**MINUTES
BOARD OF BUILDING STANDARDS/
ARCHITECTURAL BOARD OF REVIEW/SIGN REVIEW
REVIEW MEETING
FEBRUARY 11, 2021
5:30 P.M.
VIRTUAL MEETING**

Under the orders of the Governor and Director of Health of Ohio, the Board of Building Standards/Architectural Board of Review/Sign Review will meet remotely until further notice.

City of Lakewood
Architectural Board of Review
Approved as set forth in the minutes.

**Docket No. 02-10-21A & 02-10-21A - 14210 Madison - Primoz Pizza
Commercial Renovation and Sign Review - February 2021**

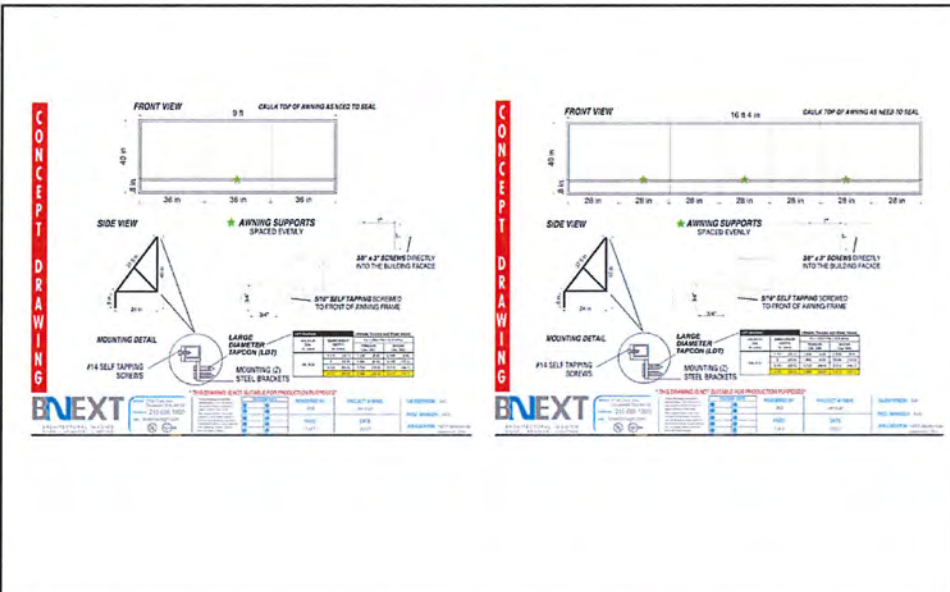
Adelle Wincek, BNext Awnings & Graphics Inc. was present to explain the requests. There was discussion between the members and applicant regarding the location of the awning. Staff recommend the sign boards remain black, the additional signs were removed, and the temporary sign be removed. Public comment was closed as no one addressed the request.

- Recommend sign boards to remain black and awnings installed within the area defined by the sign boards
- Recommend removal of window graphics; exceeds allowable square footage for signage; or apply for a temporary sign permit for one banner sign

- Awning on front to be below window supports

- Awning on side to be under stone below 2nd floor
- All the members voting yea, the motion passed.

- Sign board to be black, only one sign permitted
- City/Owner to resolve excessive signage in windows

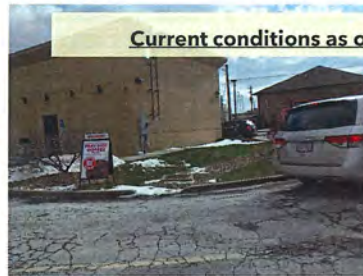
The sign plan was discussed. The pylon/pole sign was removed from the application. Staff stated there was no clearance bar and should be removed from the proposal; no variance was required. Public comment was closed as no one addressed the requests.

- Recommend removal of DD logo on clearance bar; requires a variance
- Applicant has removed pylon/pole sign from application
- City would like clarification on drive-thru versus walk-in customers/sales
- Recommend removal of temporary signage; apply for one temporary sign permit

- Applicant shall reduce or remove temporary signs as directed by the City

**Docket No. 12-137-20 - 18260 Cilantro Taqueria
Sign Review - February 2021**

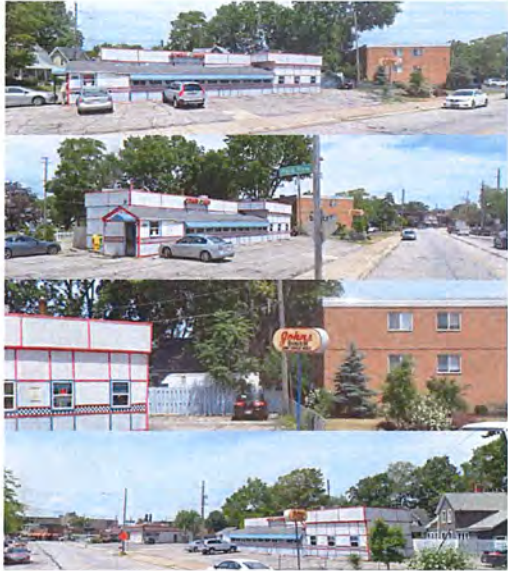
Adelle Wincek, BNext Awnings & Graphics Inc. was present to explain the request. The members and applicant confirmed it was a two-sided sign, discussed the framing and pole color. Staff requested the temporary signage was removed. Public comment was closed as no one addressed the request.

- 1329.05 (i) - existing pole signs may be refaced as long as the cabinet, pole, or structure is not modified in any way. Any such modifications other than refacing the cabinet requires removal of the pole sign.

- Pole shall be painted black.
- Applicant shall coordinate temporary signage, eliminating as directed by the City.
